COUNCIL SUPPLEMENTARY ASSESSMENT REPORT

NORTHERN REGIONAL PLANNING PANEL

PANEL REFERENCE & DA NUMBER	PPSNTH-420 – DA10.2025.156.1
PROPOSAL	Mixed use development comprising on-grade parking, commercial premises, pocket park and back of house facilities on the ground level; 37 shop top housing apartments, a landscaped podium, a swimming pool and resident amenities on level 1 and 41 shop top housing apartments on level 2 and subdivision of Penny Lane from Lot 1 DP271119 for integration with Lot 14 DP271119
ADDRESS	Lot 1 DP 271119, No. 5 Penny Lane, Byron Bay. Lot 14 DP 271119, No. 5 Penny Lane, Byron Bay.
APPLICANT	Planners North
OWNER	Bayshore Development Pty Ltd Community Association DP271119
DA LODGEMENT DATE	27 May 2025
APPLICATION TYPE	Integrated Development Application – Section 100B Rural Fires Act 1997
REGIONALLY SIGNIFICANT CRITERIA	Section 2.19(1) and Clause 2 of Schedule 6 of State Environmental Planning Policy (Planning Systems) 2021 declares the proposal regionally significant development as it has an estimated development cost exceeding \$30 million.

Figure 1: Section of infiltration system showing a 494mm separation distance from HSGL (4.6m AHD).

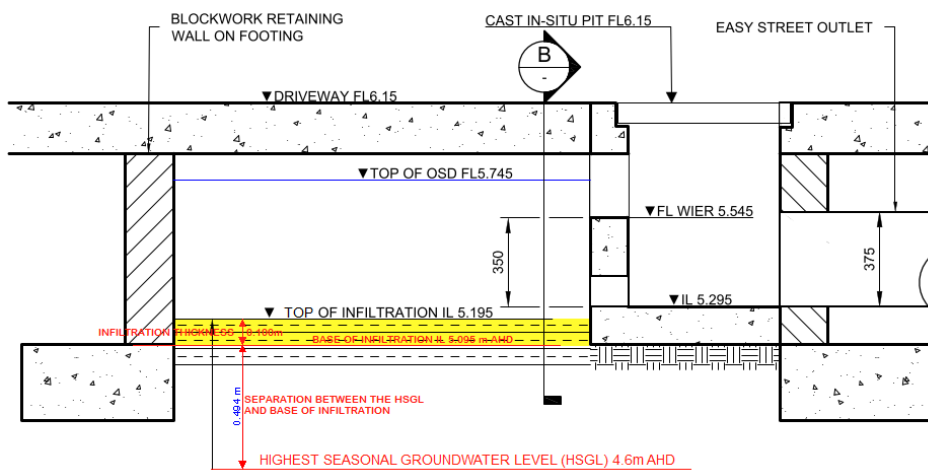
However, disagreement remains regarding groundwater levels. The Douglas Partners report identified a highest seasonal groundwater level (HSGL) of 4.6 m AHD, which Council has adopted in assessing separation distances for the OSD systems. Council considers that the southern OSD system would provide only 500 mm of separation to groundwater, which is not acceptable from a development engineering perspective.

The Applicant disputes this position, arguing that the 4.6 m AHD HSGL reflects atypical groundwater conditions caused by unusually high rainfall at the time of monitoring. They state that groundwater levels subsequently receded to between approximately 2.8 m and 3.2 m AHD once rainfall conditions normalised.

On this basis, the Applicant maintains that no substantial design changes to the southern OSD system are required. They further contend that, even if higher groundwater levels are assumed, the reduced separation distance remains acceptable, as the proposed filter media is capable of achieving the required water quality targets, as demonstrated through MUSIC modelling.

This assessment adopts the more conservative HSGL of 4.6m AHD based on the findings of the 2021 Douglas Partners report. When measured against this value, the current system design is non-compliant with Council's engineering requirements and does not provide adequate separation distance from the highest ground water levels likely to be encountered on the site.

Accordingly, it is recommended that the Southern OSD infiltration system be deleted from the scheme and replaced by a proprietary stormwater treatment device that is appropriate to the site constraints and capable of achieving Council's adopted stormwater quality objectives. Details of the new system are to be provided for approval as part of the construction certificate application.

Figure 3: Podium Section. New planter structures are proposed to provide deeper soil profiles in the central spine of the podium.

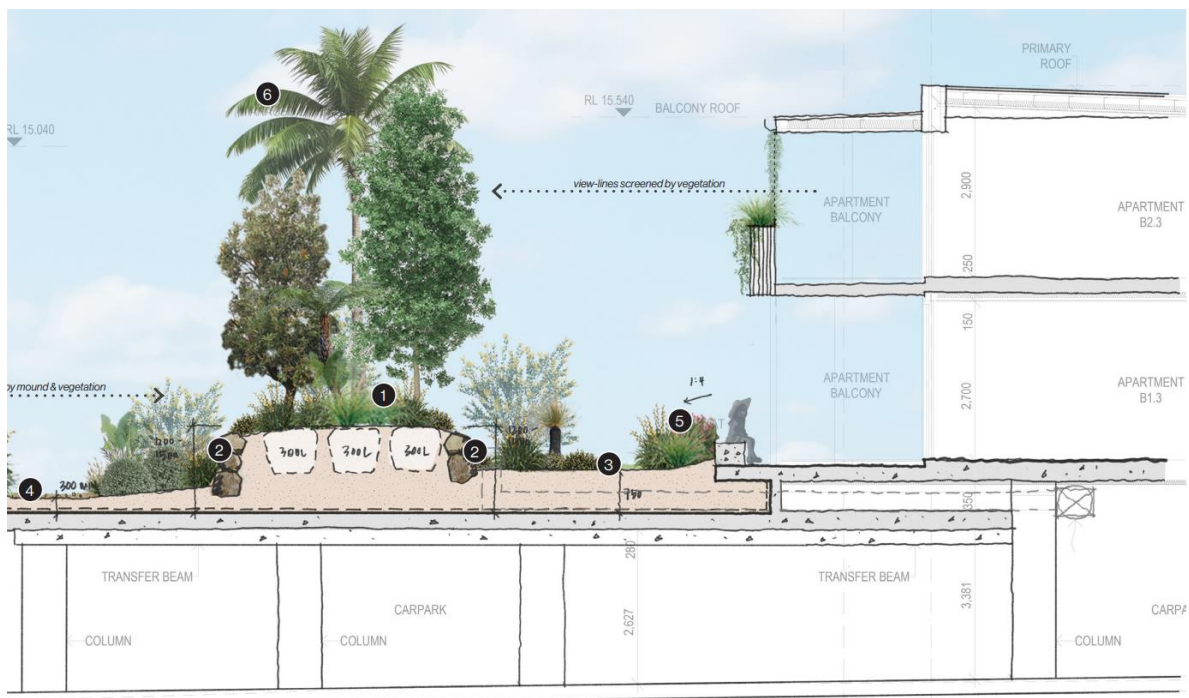
Council's Assessment Report identified concerns that the landscaped podium did not provide sufficient soil depth to support the plant species proposed in the Landscape Concept Plan, which included Bangalow and Pandanus palms.

In response, the podium design has been revised to incorporate three raised planter structures along the central spine of the platform, providing soil depths of up to 1,200 mm to accommodate mature trees and palms. The remaining podium areas will have soil depths ranging from 300 mm to 750 mm, suitable for a variety of groundcovers, succulents, and grasses.

The detailed landscaping plan is considered to satisfy the requirements of the Record of Deferral and generally addresses the concerns raised in the original Council Assessment Report. Adequate soil volumes are provided to support mature native vegetation within the centre of the podium, facilitated by three separate retaining structures. Garden beds along the Wallum Street frontage will also partially screen the ground-floor car parking area and enhance the visual presentation of the building's primary façade. In addition, a maintenance plan has been submitted, outlining the methods for the establishment, ongoing maintenance, and irrigation of landscaping across the podium.

Figure 4: Wallum Place Section showing native shrubs, grasses and ferns in front of the ground level car parking area.

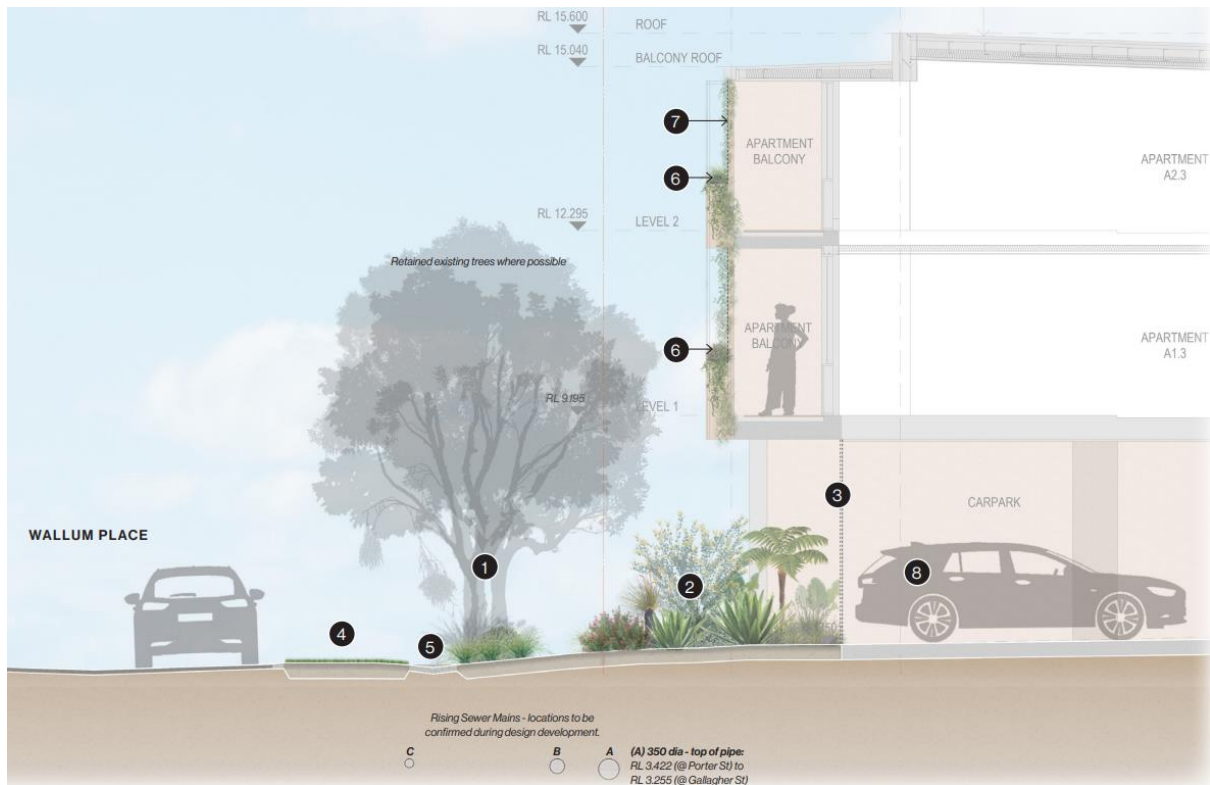
Additional landscaping is proposed along the Wallum Street frontage to help screen the expansive ground-floor car parking area. This will comprise garden beds extending across the frontage, planted with a mix of native shrubs, grasses, and ferns.

Figure 6: Updated CPTED plan – lighting and gates will be installed on the walkway.

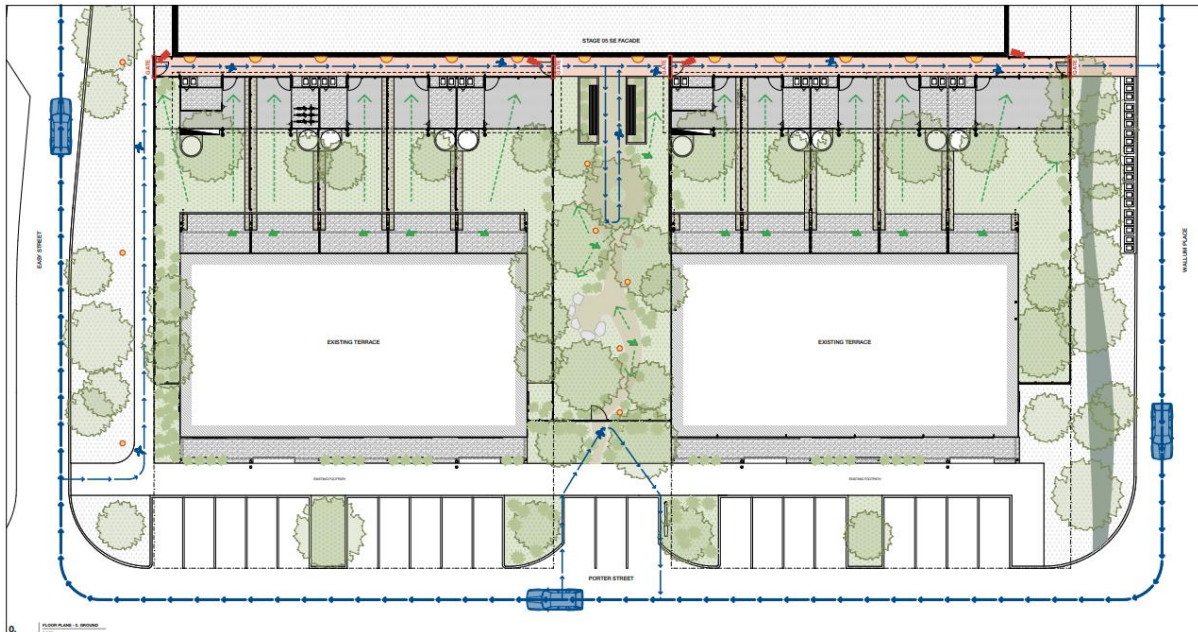
The Panel raised concerns during the meeting that the south-east walkway between the new Stage 5 building and the Porter Street terraces was narrow, secluded, and created potential safety and security issues. The Record of Deferral requires the Applicant to provide further information on public safety and CPTED resolution of this space.

An updated plan has been provided detailing the following measures to improve the safety and security of the walkway in accordance with established CPTED principles:

1. **Access control:** Access to the walkway will be restricted by four gates. Two at the Easy Street and Wallum Pace ends and two at each side of the pocket-park crossing. The gates will be accessed by swipe-card or keyed access for residents and authorised tenants only, integrated with the existing Habitat-wide access-control system for shared facilities.

2. **Surveillance:** Four CCTV cameras are proposed, one at each of the walkway gates. The cameras are oriented to cover each gate, securing the points where unauthorised entry would likely occur. Habitat operates three random nightly security patrols across the precinct. One is a foot patrol that is intended to check the south-east walkway.

4. **Lighting:** Lighting along the walkway will be designed by a suitably qualified electrical engineer and detailed at the construction certificate stage. The lighting will be continuously illuminated so that no portion of the walkway is in shadow at any time.

The proposed CPTED measures will improve safety and security of the new walkway and are considered to satisfy the requirements of the Record of Deferral. Security gates will limit access to authorised persons while wall-mounted lighting and CCTV cameras will ensure the south-east walkway is well-lit and has good visibility. Conditions of consent are recommended to ensure that the proposed CPTED measures are installed prior to the issue of an occupation certificate and maintained at all times.

Figure 7: Amended car parking plan showing a washing bay.

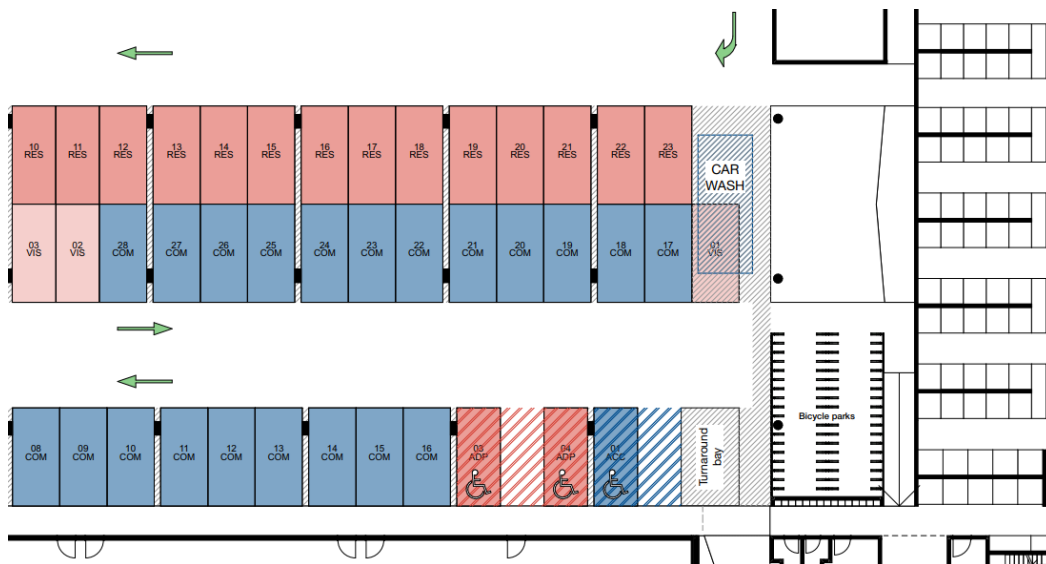
Part D1.10.6 of DCP 2014 (Site Facilities) requires 1 car washing area to be provided for shop top housing development, at a general rate of 1 bay per 10 dwelling units. The car wash area must have minimum dimensions of 7.6 m by 3 m, and may be part of a visitor space, driveway or turning area where it can be shown that the wash bay will not cause undue conflict of use. The proposed development has 78 residential units and requires 8 car washing bays under DCP 2014.

The amended car parking plan includes 1 car wash bay at the eastern end of the car parking area, near the bicycle racks. The wash bay overlaps with one of the residential visitor parking spaces.

While the amended scheme is an improvement over the original design, one car wash bay is considered insufficient for an apartment complex containing 78 units and does not satisfy the Objectives and Performance Criteria of Part D1.10.6 of DCP 2014.

It is considered that the current lack of car washing facilities can be addressed through a condition of consent that requires amended plans to be approved prior to the issue of construction certificate identifying at least two car wash bays within the development or the broader Habitat complex.
